The Great Grid Upgrade

Norwich to Tilbury

Design Development Report

AENC-NG-CNS-REP-0005

Figure 5.29 Alignment at Edney Common

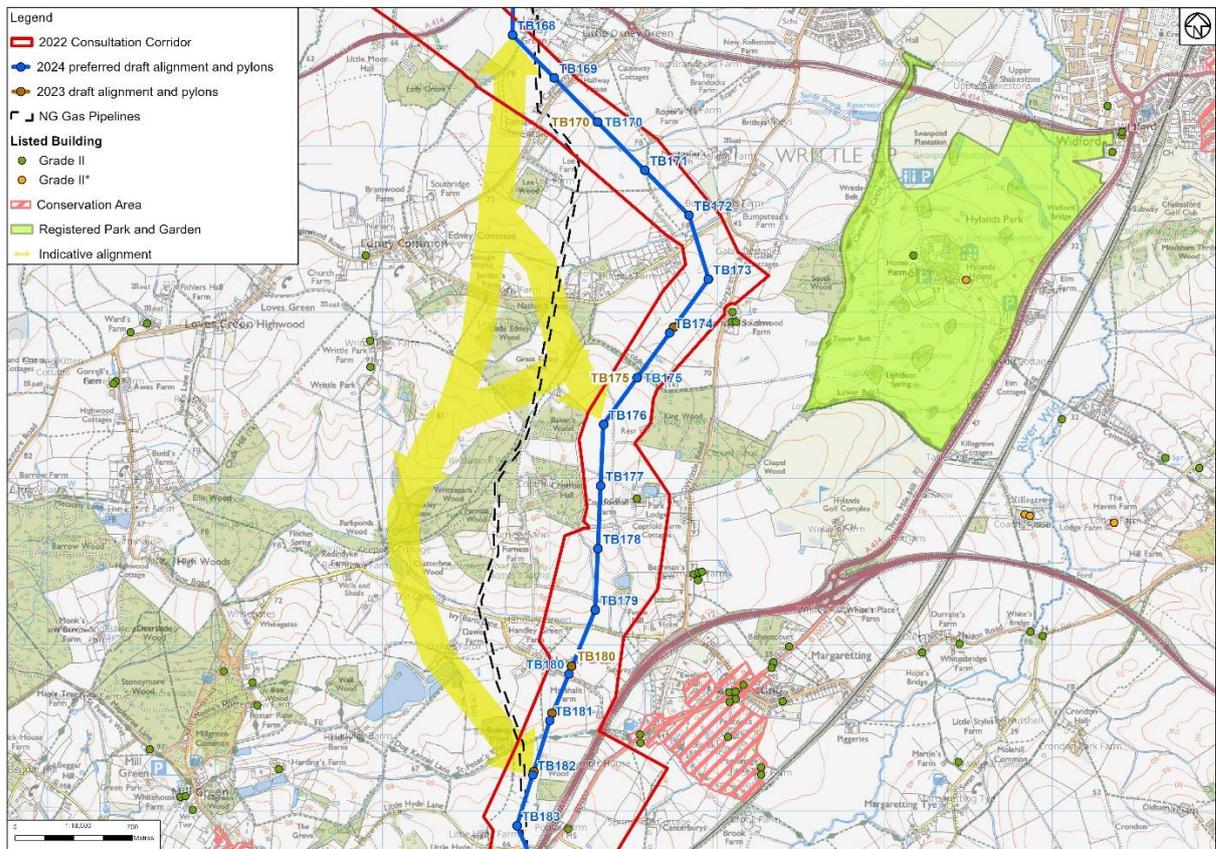
- 5.4.196 Feedback also requested routing more directly in the vicinity of Edney Common (e.g. TB158 to TB176 or TB182) to reduce effects on farming activity, and potentially also benefitting from routing more extensively in valleys (see Figure 5.29). Feedback emphasised that several areas of Ancient Woodland, that were identified as a main reason for these routes being less preferred in the 2023 Design Development Report, were subject to extended rotation coppice regimes. After reconsideration it has been concluded that the more regular need to control the height of vegetation under overhead lines (requiring coppicing over short rotations) would lead to a change in the habitat. This change is not considered to be compatible with the preservation of the ancient woodland habitat and these alternatives are still considered to be less preferred. As such we are currently progressing with the 2023 preferred draft alignment in this location but with some in line adjustments to pylon positioning.

Figure 5.30 Alignment at Margaretting & Ingatestone

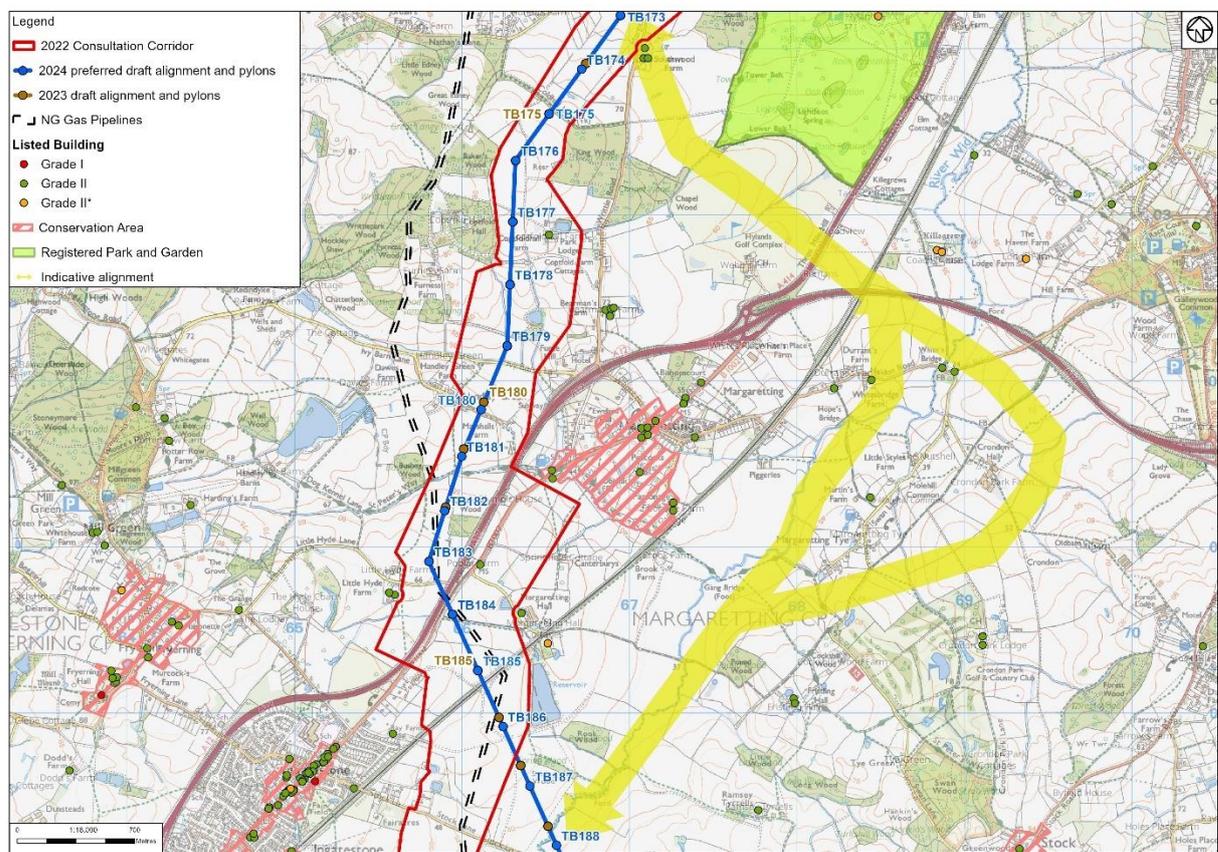
- 5.4.197 Feedback responses also proposed an alternative alignment to the east of Margaretting (see Figure 5.30). This would be from around TB175 to pass the southern edge of Hylands Park and directly over Hylands Golf Complex. Crossing the rail line to east of the

A12 and A414 junction the alignment would turn south along the east side of the River Wid reconnecting with the 2023 preferred draft alignment to the east of the Church of St Mary at Buttsbury. Localised variations were considered for part of the alternative passing to the east and west of a group of properties located along Swan Lane. Overall, the alternatives would be around 1 km longer, (for the shortest western alternative and longer than a variation passing to the east of Swan Lane) and less direct with a much larger angle change around the A12 crossing. Effects on residential amenity and heritage assets would generally be transferred from receptors around the 2023 preferred draft alignment to receptors on these alternatives. Additionally, there would be increased levels of residential amenity effects for the alternative passing to the west of Swan Lane, as a result of an increased number of properties in closer proximity to potential alignments in the area around Maldon Road and Swan Lane. Due to the increased level of effects and the longer route length these alternatives are less preferred and have not been taken forward.

Figure 5.31 Alignment at Stock

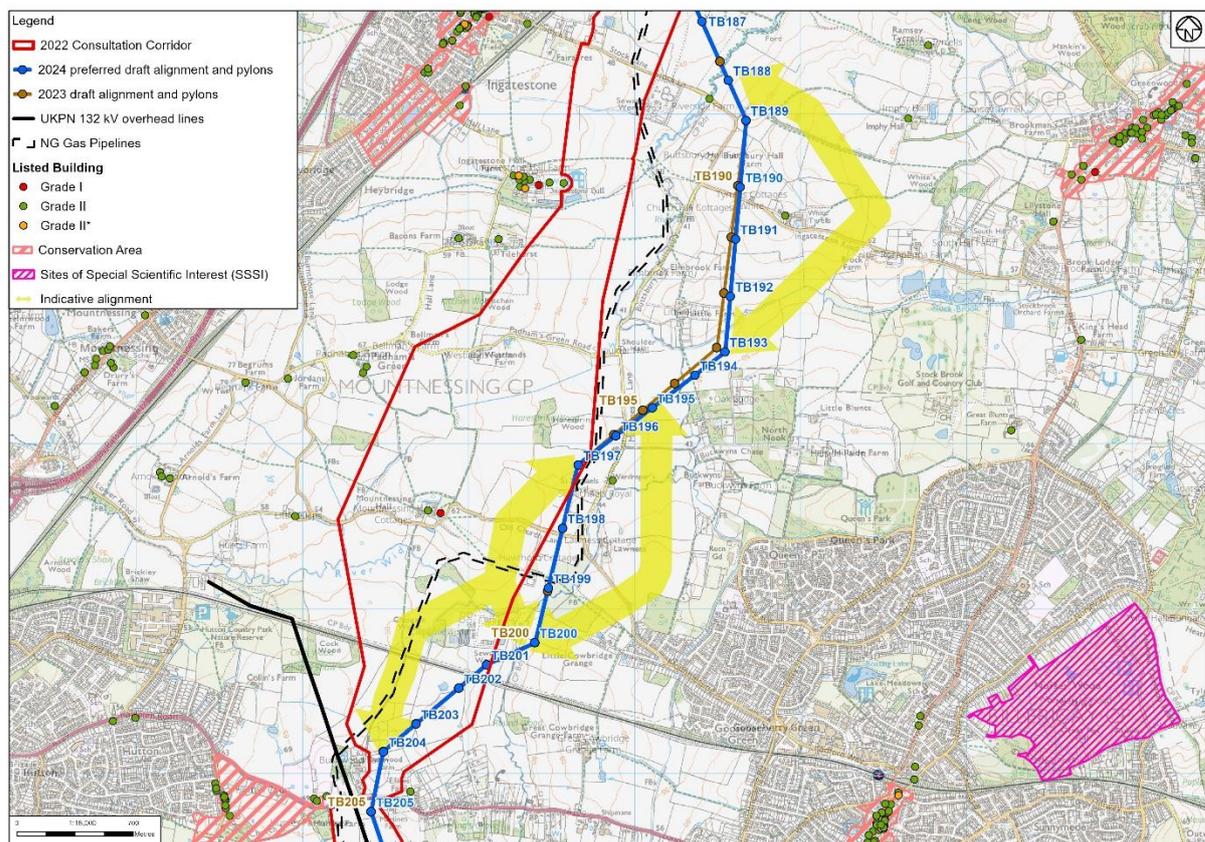
- 5.4.198 The Project moves into Section G around the crossing of the A12 to the north of Ingatestone.
- 5.4.199 Consideration of feedback and further technical review have led to a slight shift eastward in the alignment (see Figure 5.31) between TB189 and TB197 (identification unchanged since 2023) to reduce oversail of an animal rescue establishment and avoid the placement of pylons within flood risk areas. The potential for interaction with Napps Field Airfield (also referred to as Brock Farm) was also identified by respondents but, through engagement with the landowner, it has been identified that this airfield is no longer operational, and the owner has no current plans to restore flight activities.

5.4.201 Conflicting feedback was provided for the section to the east of the Grade I Listed St Giles Church (see Figure 5.31) with respondents seeking to reduce residential amenity effects or reduce effects on an area recently planted with saplings as part of restoring wildlife interest. Some respondents proposed a move of the 2023 preferred draft alignment further east but this is considered less preferred, as while there would be some benefit to individual residential amenity, there would be a transfer of effects and an increase in such effects to a larger number of residential properties on the western edge of Billericay.

Figure 5.32 Alignment at Herongate

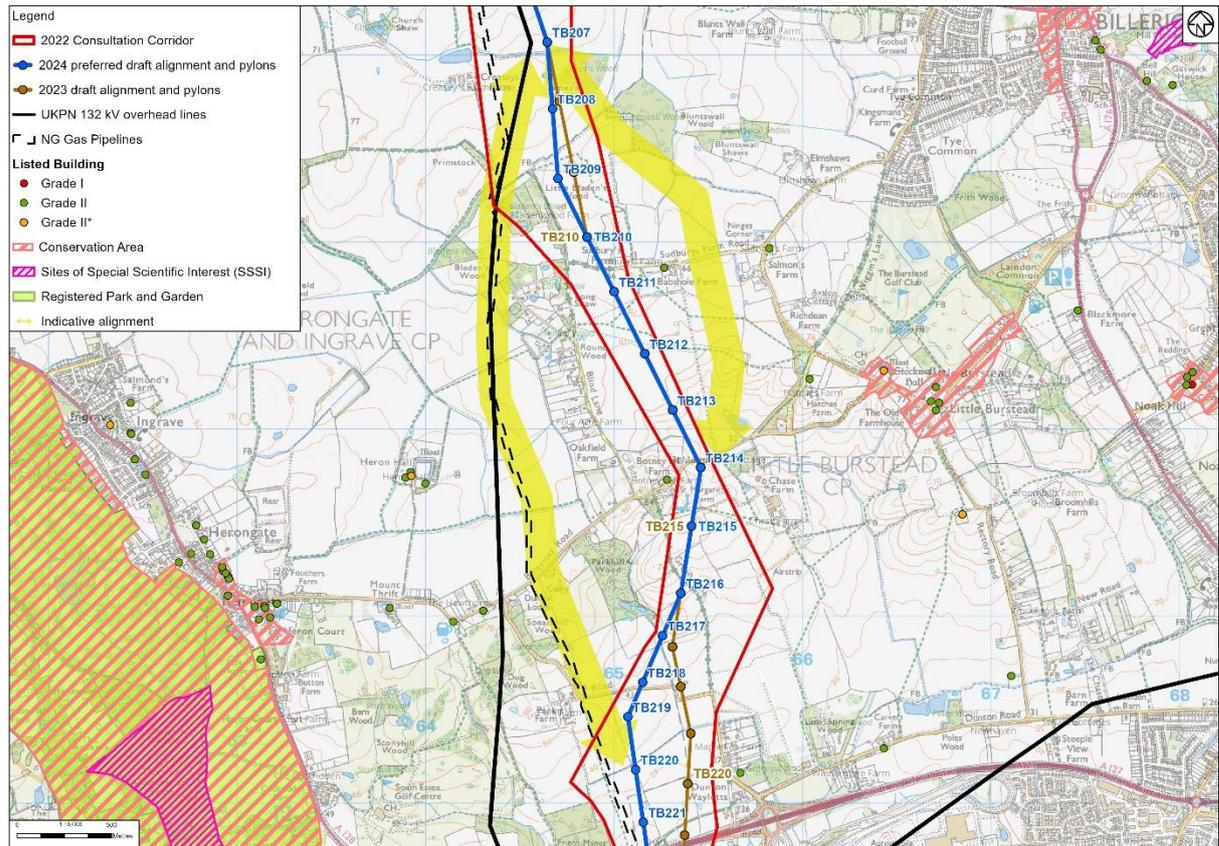
- 5.4.206 Feedback also suggested an alternative for routeing at the pinchpoint by adopting the route of the 132 kV overhead line (replacing the 132 kV overhead line with an underground cable) (see Figure 5.32). Whilst the potential for this to reduce residential amenity effects around this location is noted, this would be as a result of either increased ecological effects, due to the requirement for a swathe of tall vegetation to be cleared through woodland or would require oversail of the Woodland School grounds. The adoption of the alignment of the 132 kV overhead line are considered less preferred to the 2023 preferred draft alignment.

- 5.4.208 South of Herongate, feedback requested consideration of alternatives that either adopted or close paralleled the existing 132 kV overhead line that passes to the west of Blind Lane. As shown on Figure 5.32, respondents cited in particular their opinion that there was space to the western side of the Herongate Woodland Cemetery that could be used for the 400 kV routeing. This suggestion has been reviewed however the perceived space, adjacent to the western side of the cemetery, has been identified a being occupied by a high-pressure gas pipeline with space further restricted by an adjacent residential property. The particular arrangement of the gas pipeline and residential property, along with areas of woodland, is such that an alignment for a 400 kV overhead line cannot completely avoid oversail of the cemetery area. This is not considered to be consistent with the Holford Rules and planning policy and is therefore less preferred.

- 5.4.209 The alternative to adopt or closely parallel the existing 132 kV overhead line, which is positioned slightly further west of this, is also restricted by various environmental features and constraints. To the west of the woodland cemetery the 132 kV overhead line passes between residential properties. The larger scale 400 kV infrastructure is more likely to oversail in this location. It would also lead to effects on the South Essex Golf Centre and lead to increased effects on the scheduled monument 'Moated site east of Heron Hall'. For these reasons it is considered that an alternative adopting or closely paralleling the 132 kV overhead line is less preferred.

Figure 5.33 Alignment at Dunton Hills Garden Village

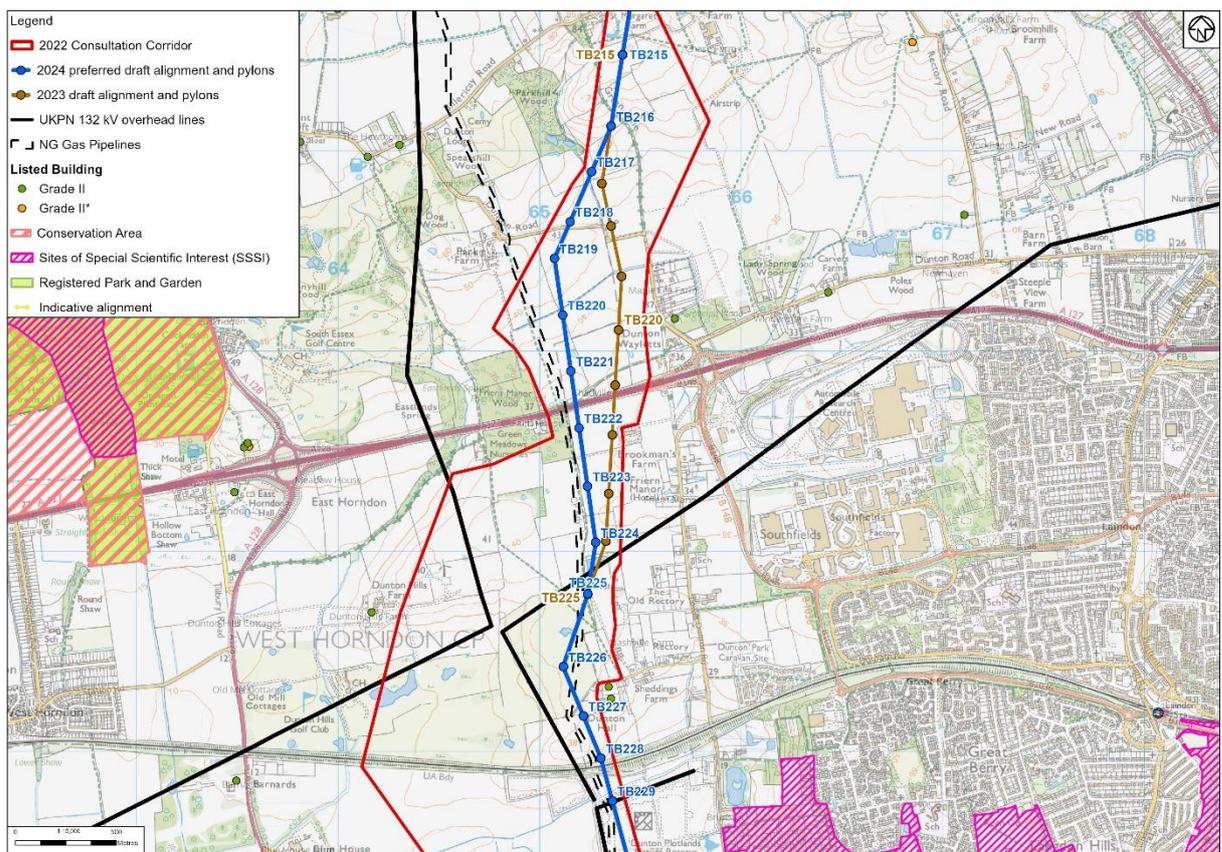
- 5.4.211 Feedback also identified additional housing proposals to the east of Dunton Hills Garden Village, with part of the proposals to the west of the gas pipeline and a larger part to the east. Based on an indicative masterplan provided in the feedback, the proposals would be potentially impacted by pylons TB221 to TB224 within the 2023 preferred draft alignment (see Figure 5.33).

- 5.4.214 Feedback has also requested consideration of underground cables through the Dunton Hills Garden Village development area. The route of any cable connection would be likely to have to adopt the 2023 preferred draft alignment to cross the A127 as there is insufficient space for the majority of the required cable trenches between a residential property and the gas pipeline to allow for trenchless crossing for all the cables. Even if realigned to subsequently follow the gas pipeline safety zone it is estimated that between 2 to 3 hectares of development land would be removed (as no development could occur above the cables). Given the absence of a clear basis in NPS EN-5 for the use of underground cable in this location (it is not subject to designation as AONB or similar), the ability for detailed masterplanning to reduce potential visual effects and the additional cost implications of the additional cable (of around a minimum 2 km), and the potential loss of development land National Grid does not consider it necessary to change from overhead line for the 2024 preferred draft alignment in this location.
